**STAFF RECOMMENDATION**  
**118 Pembroke Avenue**  
**March 21, 2012**

**Application:** New Construction—Side and rear addition; Accessory Structure; Setback reduction

**Description of Project:** Construct rear and side additions and new accessory structure. The project requires a reduction to the rear setback for the accessory structure.

ARCHITECTURAL SITE PLAN

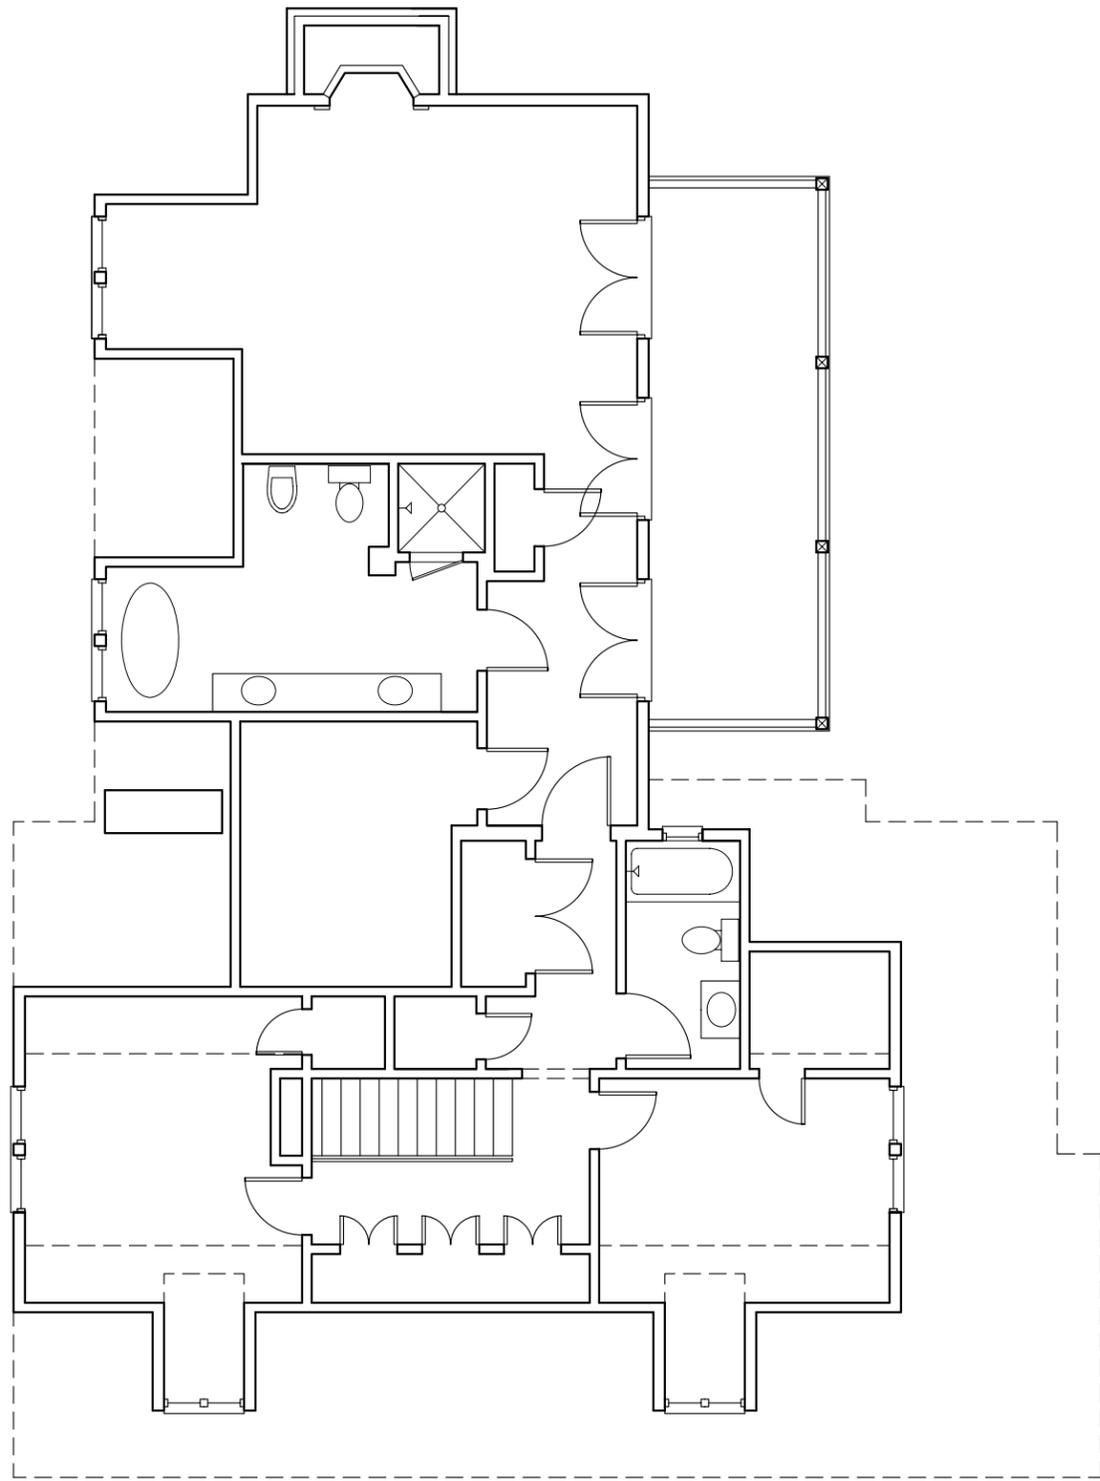
**Location & Setback:** The proposed addition meets all base zoning requirements for setbacks. It expands an existing addition approved by the Commission in 2005 and does not connect directly to the historic house. Part of the proposed addition is a side addition that will connect to the north side of the existing addition and will extend a maximum of fourteen feet (14') beyond the side wall of the historic house. Staff finds this side addition appropriate for several reasons. Because the property's lot is irregularly shaped

The proposed accessory structure is located in the rear of the property behind the historic house. Its garage doors face Windsor Drive, which is appropriate since the site does not have alley access. The accessory structure meets the required front and side setbacks. However, because the structure is more than seven hundred square feet (700 sq. ft.), Codes requires that it be placed a minimum of twenty feet (20') from the rear property line. The garage is proposed to be six feet, eight inches (6'8") from the rear property line, and it therefore requires a reduction to the rear setback. Staff finds that the location of the garage matches where accessory structures were historically located and finds that the rear setback reduction meets the design guidelines.

**WEST ELEVATION**

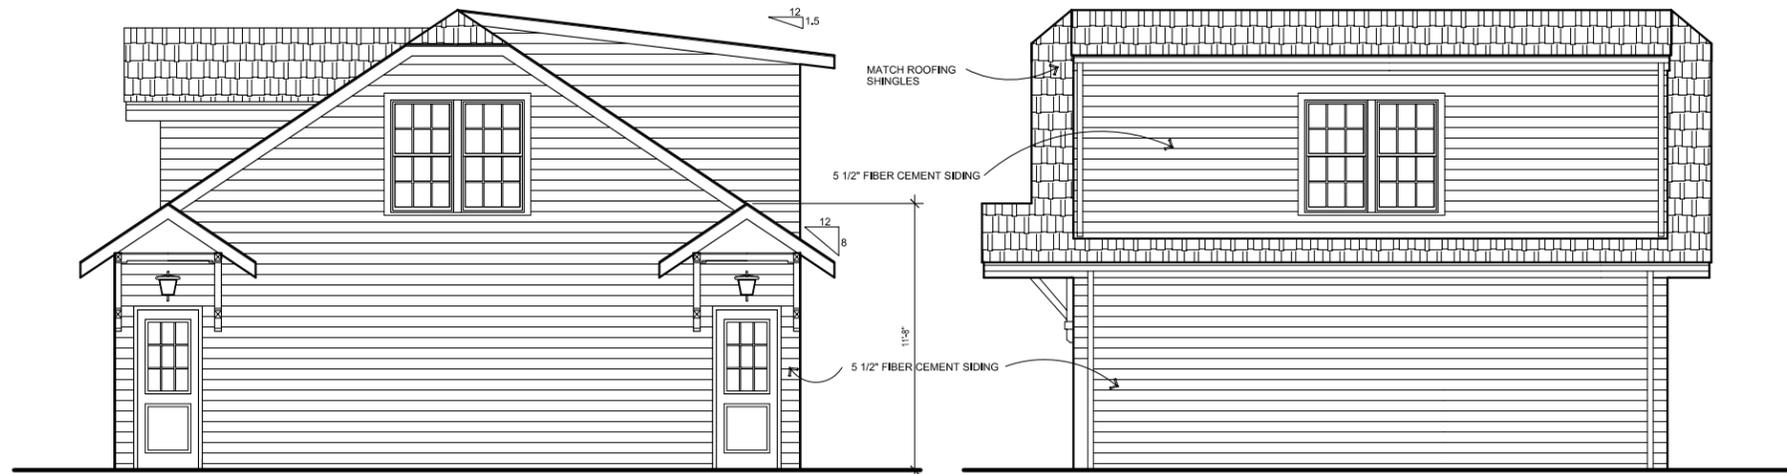
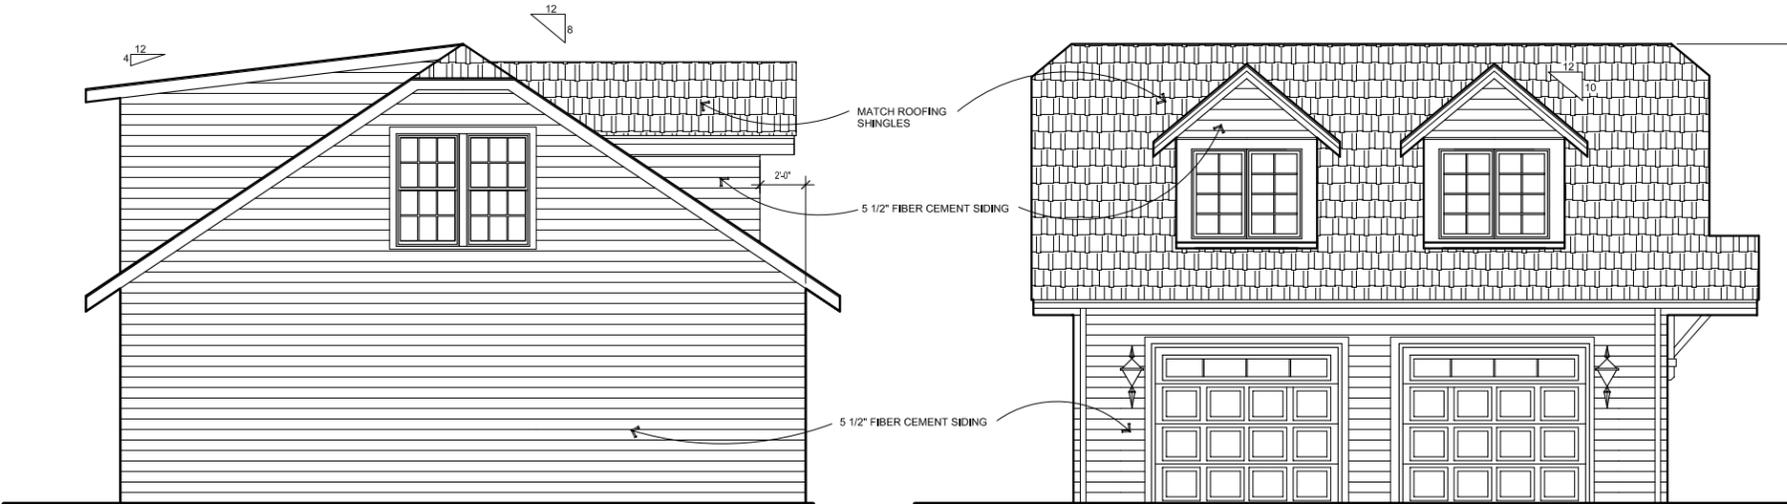
Roofs: The historic house's primary roof form is a clipped side gable with a ten-twelve (10/12) pitch. The c. 2005 addition has a clipped front-gable roof form with a pitch of ten-twelve (10/12). The rear portion of the proposed addition will continue the existing addition's ten-twelve (10/12) front gable form. The side portion of the addition will have a flat roof, and the shed dormer will have a slope of one-and-a-half to twelve (1.5/12), which matches an existing shed roof form on the existing addition. The accessory structure's primary roof form will be a clipped side gable with a roof slope of eight-twelve (8/12). The two dormers on the front of the accessory structure will have gabled

ten-twelve (10/12) roofs, while the shed dormer on the rear of the structure will have a four-twelve (4/12) slope.

Proportion and Rhythm of Openings: The dimension and design of windows and doors are similar to those on the existing house. The primary windows on the addition and on the accessory structure are taller than they are wide and therefore fit the proportions for historic window openings. There are no large expanses of wall space without a window or door opening on either the addition or the accessory structure. Staff asks that a condition of approval be that a four to six inch (4 -6") mullion be included between the double windows in the gabled dormers on the accessory structure.

- Staff review and approve the materials and specifications for the windows, doors, and lighting fixtures and approve the roof color prior to purchase and installation;
- A four to six inch (4 -6") mullion be included between the double windows in the gabled dormers on the accessory structure.
